CTS HERITAGE

RE: PART TWO AMENDMENT FOR THE APPROVED RIETKLOOF WEF NEAR MATJIESFONTEIN IN THE WESTERN CAPE

RE: AMENDED LAYOUT FOR THE APPROVED RIETKLOOF WEF NEAR MATJIESFONTEIN IN THE WESTERN CAPE

Map 1: Amended final layout of the Rietkloof WEF

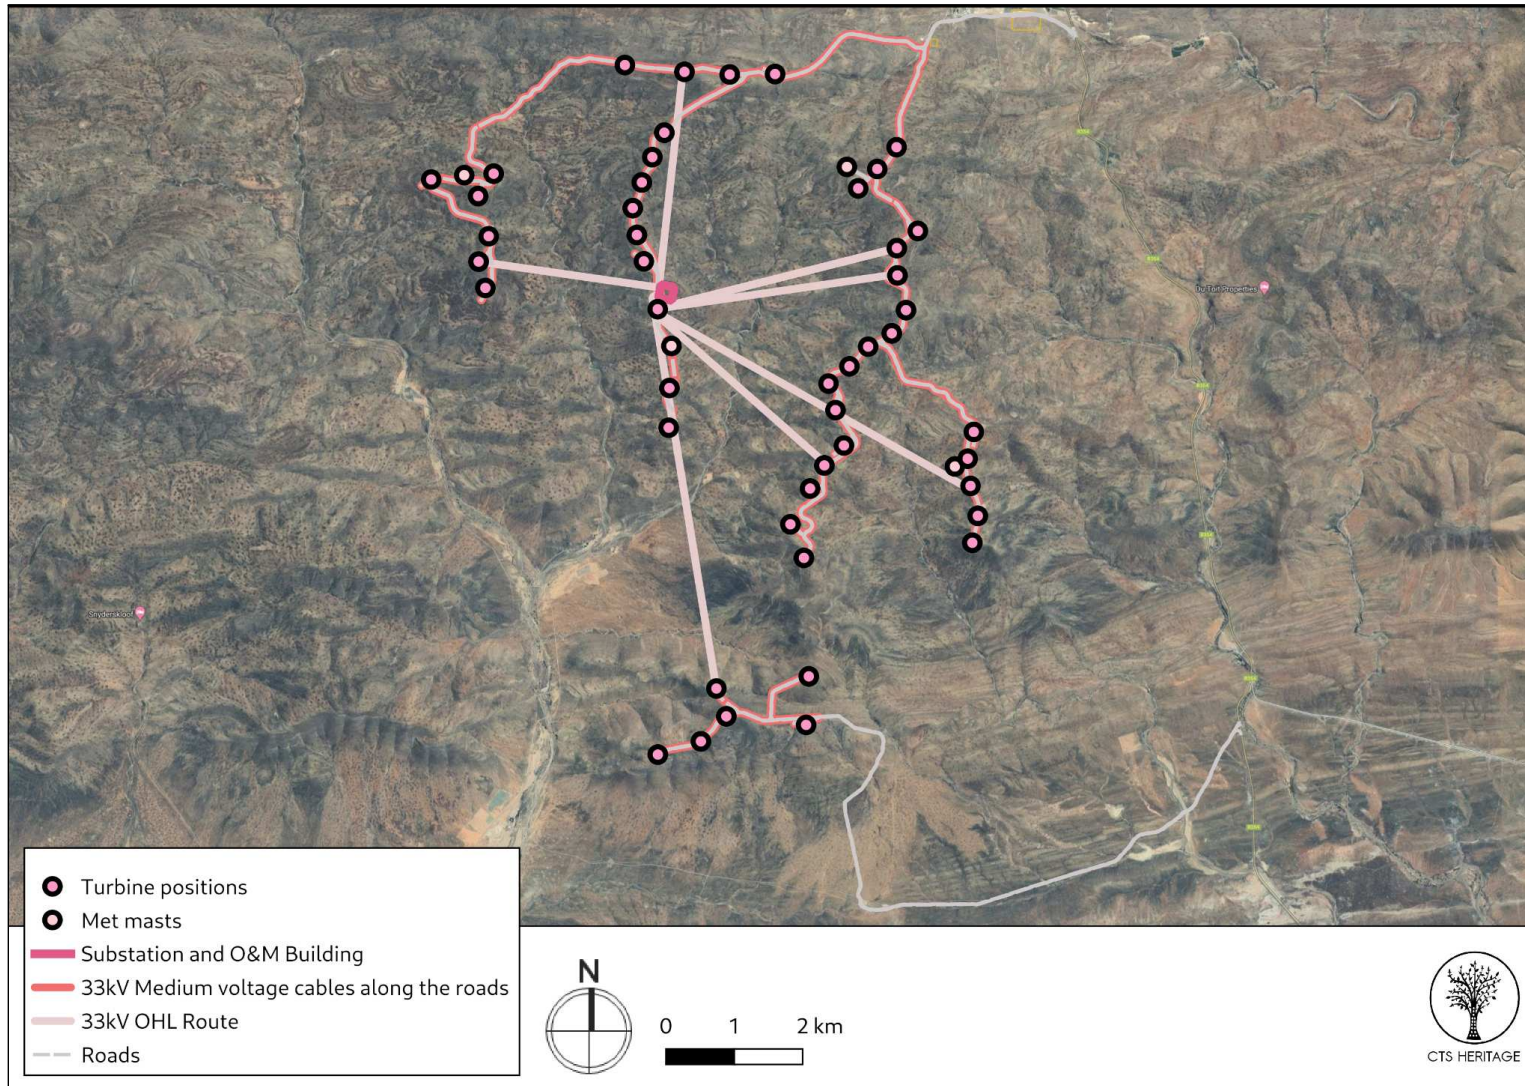
This letter is therefore drafted to confirm that the final amended layout dated November 2021 for the Rietkloof WEF does not impact any known heritage resources and adheres to the recommendations included in the CTS Heritage Walkdown report for this development (September 2021) which concludes that “The final layout for the Rietkloof WEF avoids impact to all known significant heritage resources present within the development area. The walkdown of the final layout revealed no new significant heritage resources that are likely to be impacted.”

Map 3: Track paths followed for the walkdown of the Final Layout

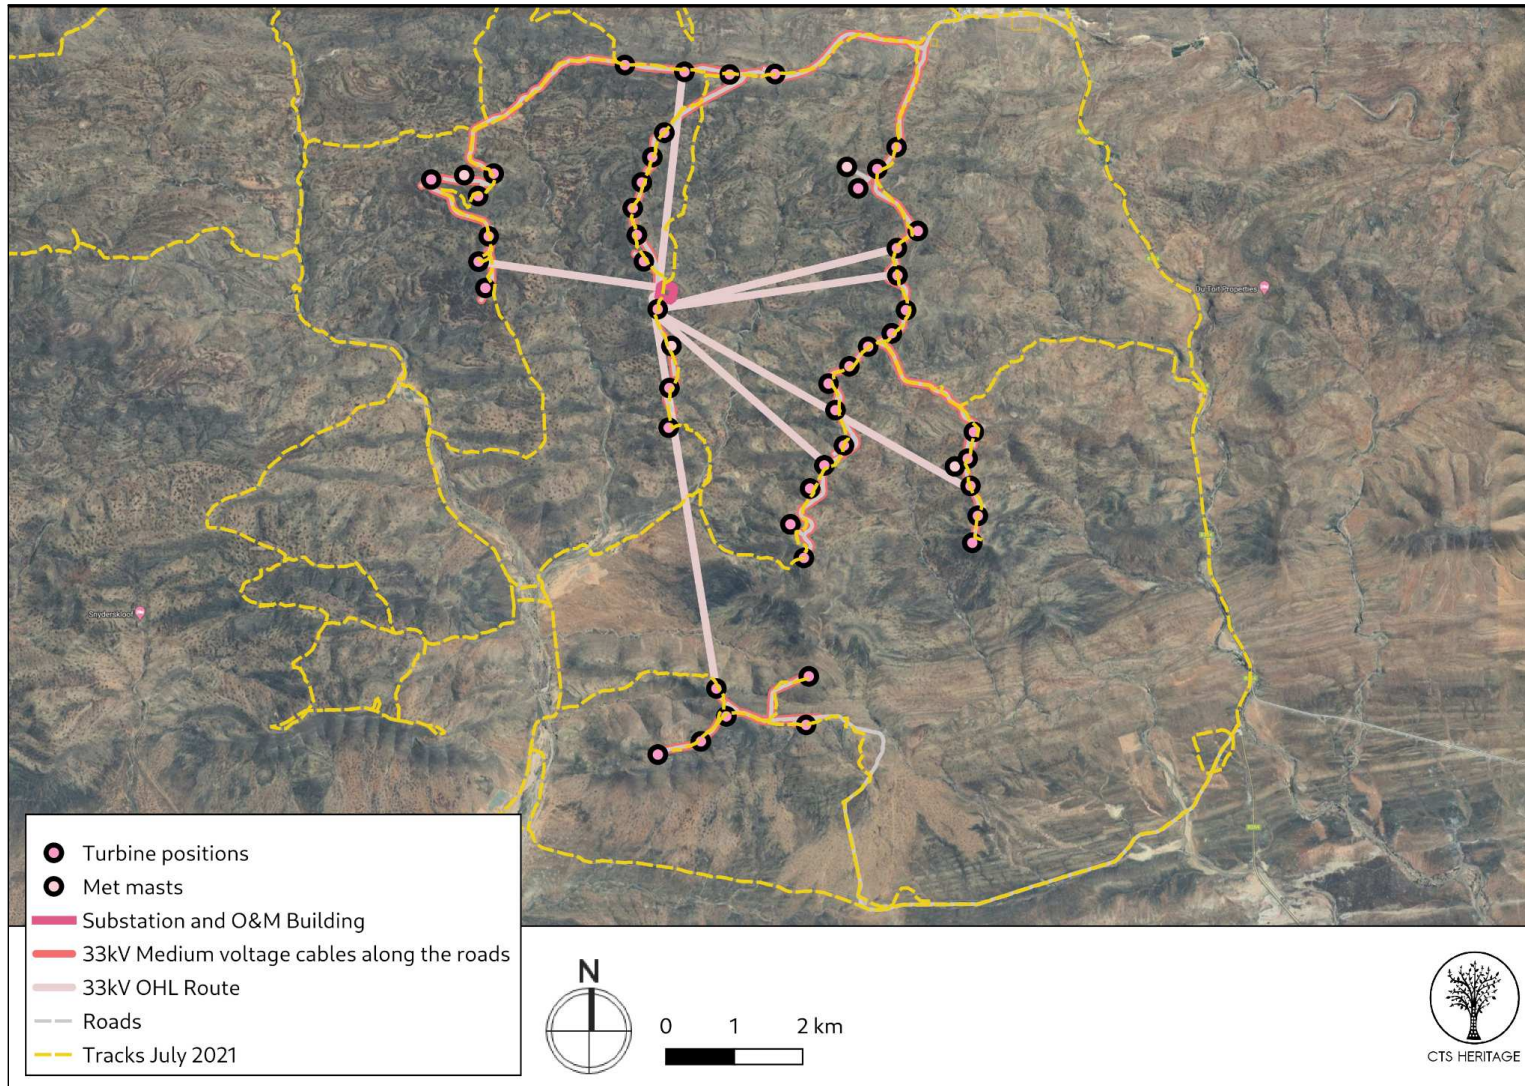
However, please note that the proposed alignments for the 33kV Overhead Lines (OHL) were not assessed as part of the Walkdown process (Map 3). As such, there remains a risk that the construction of these overhead lines may negatively impact on significant archaeological or palaeontological heritage and as such, it is recommended that the proposed locations of the footings for the pylons for the OHL be inspected for such impacts during the construction phase of the development.

Map 4: Known heritage resources overlain with the proposed amended layout (refer to Walkdown Report September 2021 for the Site details)

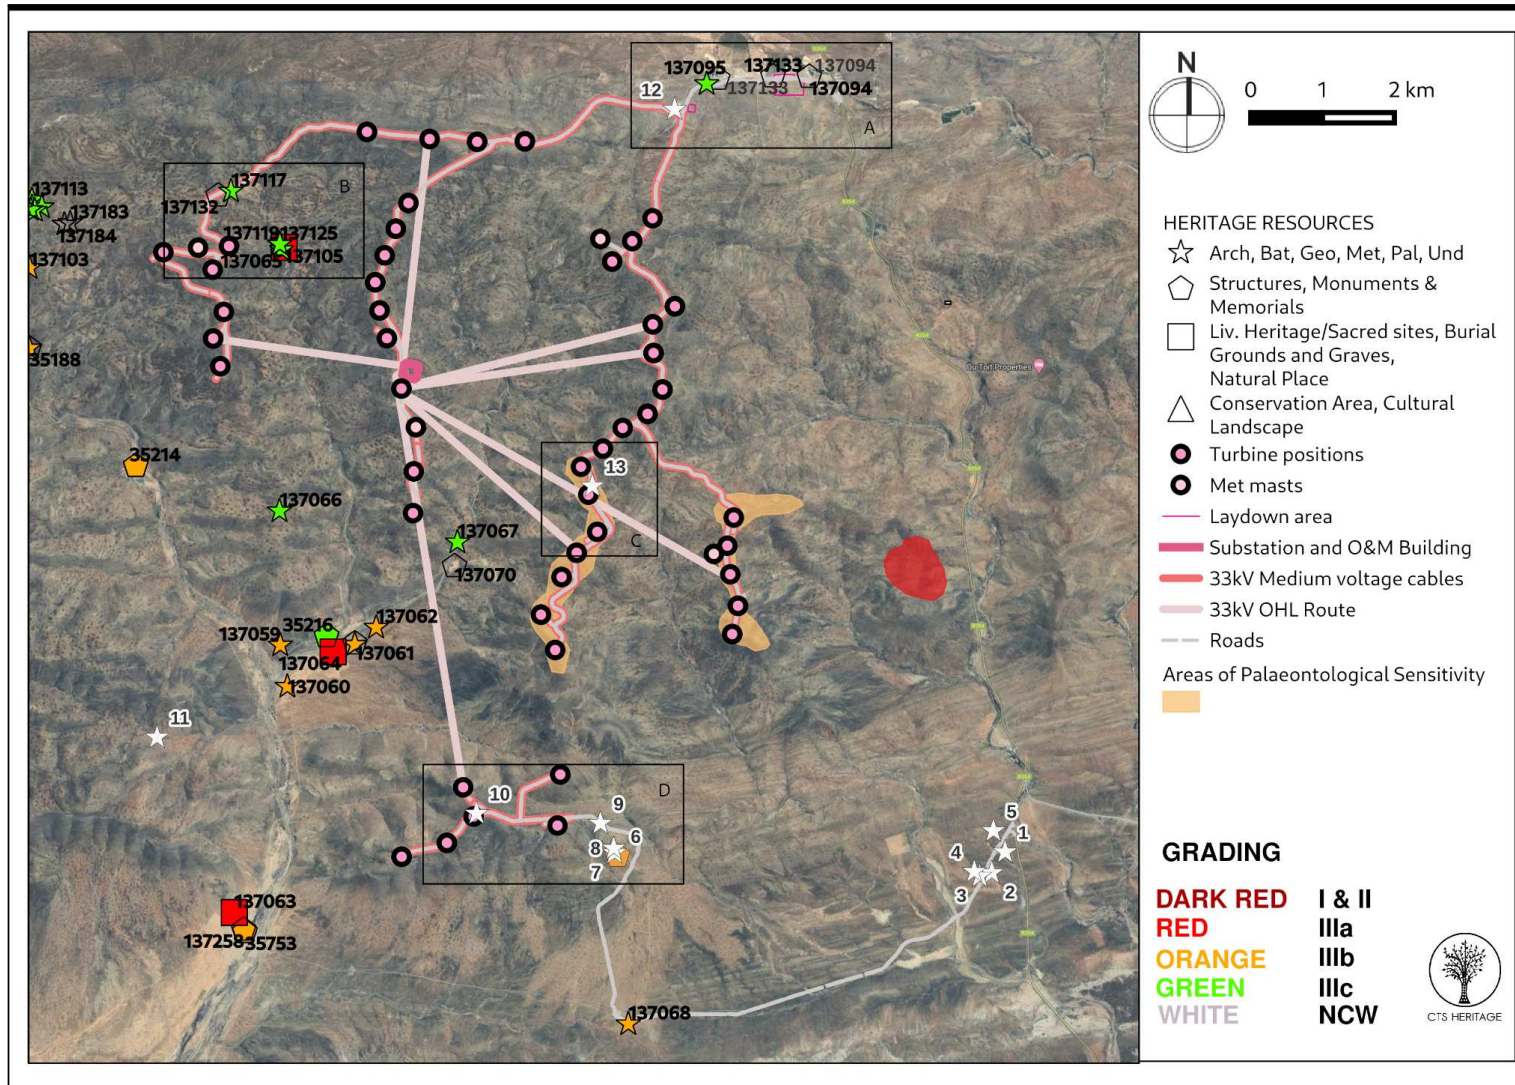
Although the EA did not make any specific conditions pertaining to the conservation of palaeontological heritage, the PIA completed for the Rietkloof WEF recommended that the area marked in Orange in Map 4 should be inspected for fossil wood occurrences by a professional palaeontologist prior to construction. It is recommended that this mitigation step be completed prior to the construction of the turbines in this area.

Map 1: Amended final layout of the Rietkloof WEF indicating the amended road alignment

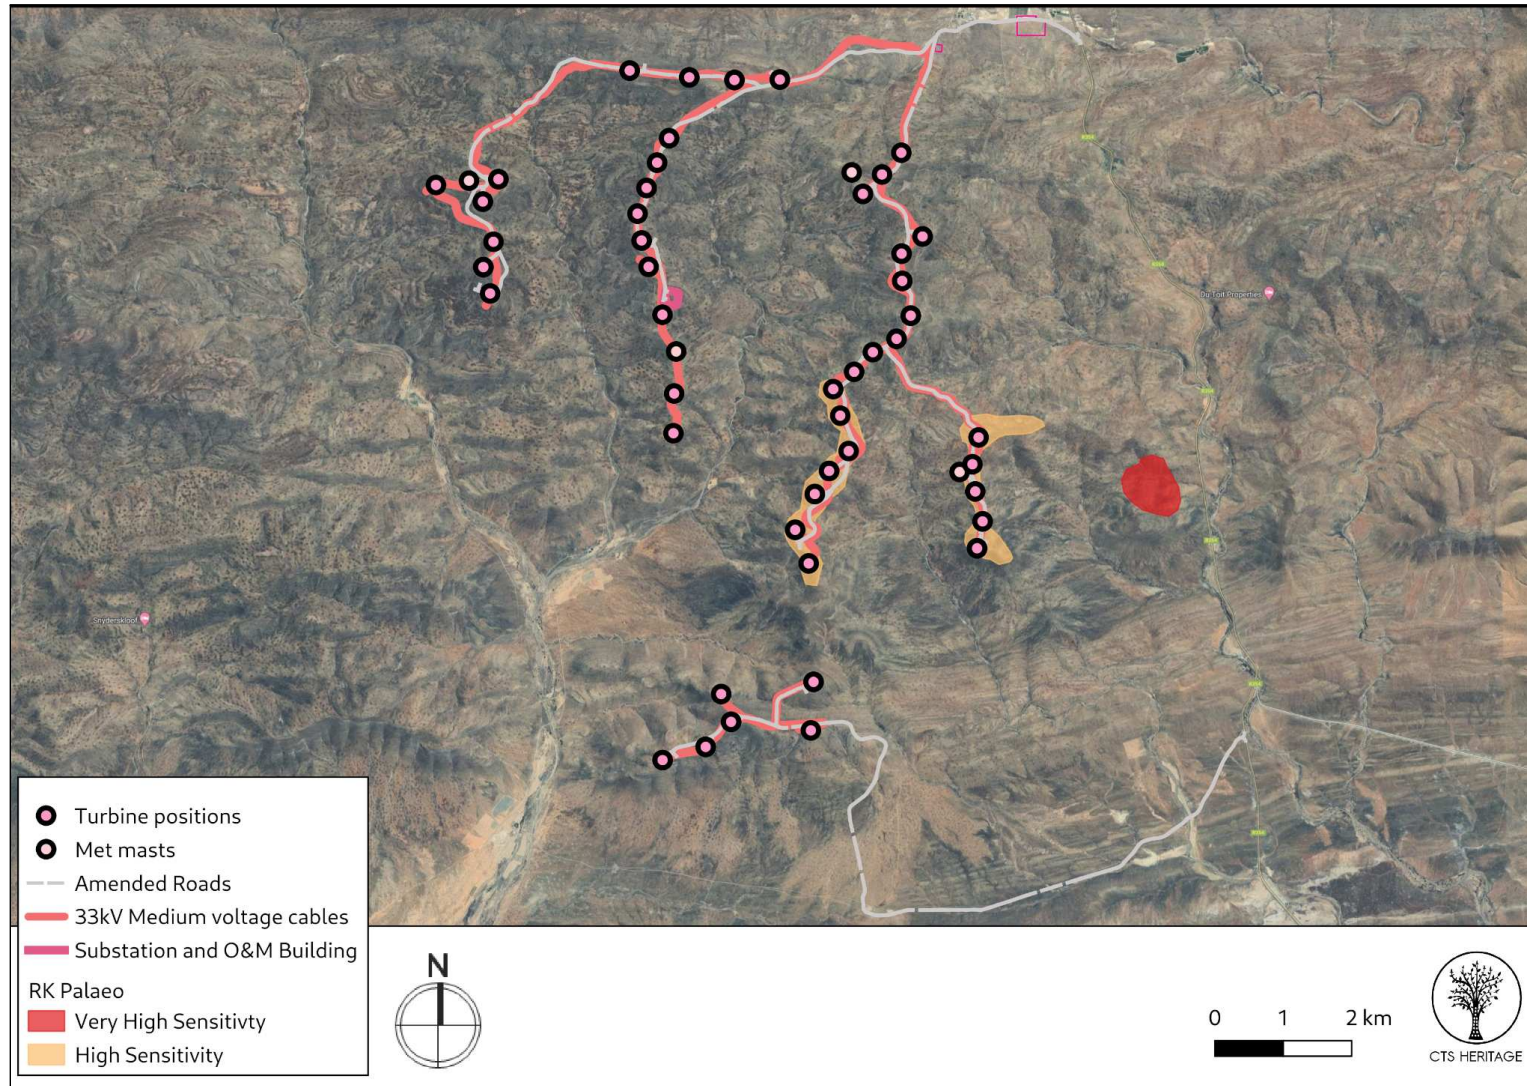
The proposed amendments consist of minor deviations (maximum deviation of approx. 600m). As with the previous layout, some of the heritage resources known from this area are located along the proposed road alignments. The road alignments have been slightly amended in the proposed amended layout, however it is not anticipated that these amended road alignments will negatively impact on significant archaeological heritage. Furthermore, it is not anticipated that the proposed change in turbine height and reduction in turbine numbers will negatively impact on heritage resources.

This letter is therefore drafted to confirm that the amended layout dated April 2022 for the Rietkloof WEF does not impact any known heritage resources and adheres to the recommendations included in the CTS Heritage Walkdown report for this development (September 2021) which concludes that “The final layout for the Rietkloof WEF avoids impact to all known significant heritage resources present within the development area. The walkdown of the final layout revealed no new significant heritage resources that are likely to be impacted.”

Map 3: Known heritage resources overlain with the proposed amended layout (refer to Walkdown Report September 2021 for the Site details)

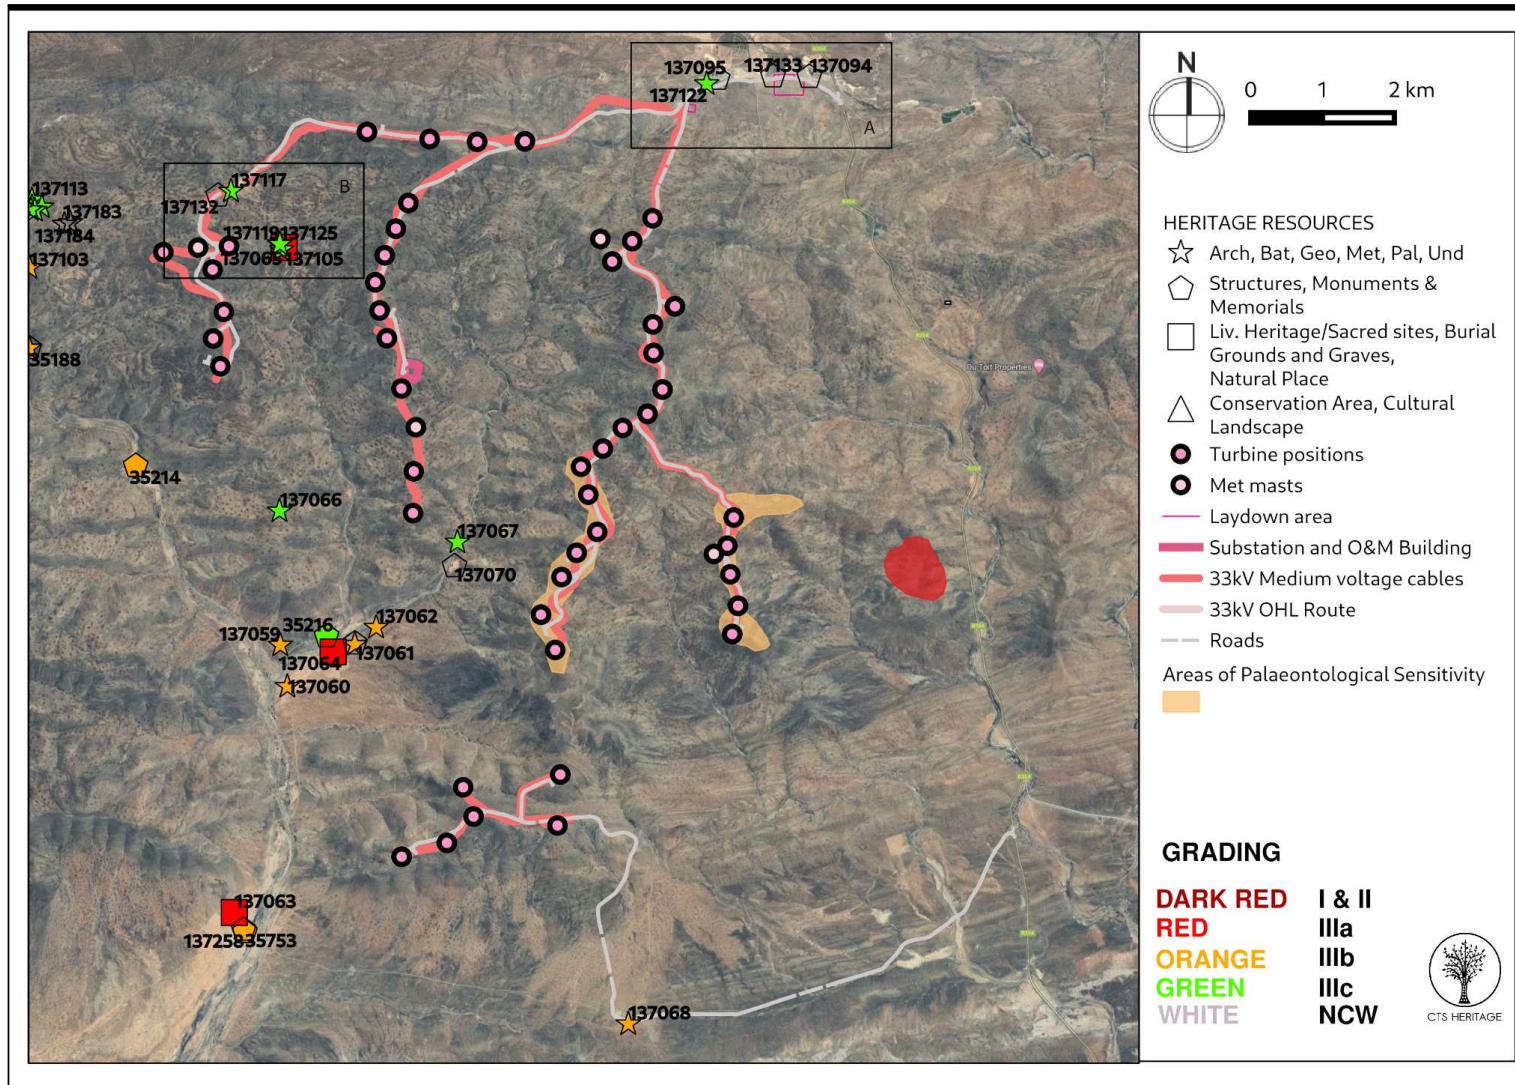
Although the EA did not make any specific conditions pertaining to the conservation of palaeontological heritage, the PIA completed for the Rietkloof WEF recommended that the area marked in Orange in Map 4 should be inspected for fossil wood occurrences by a professional palaeontologist prior to construction. It is recommended that this mitigation step be completed prior to the construction of the turbines in this area.
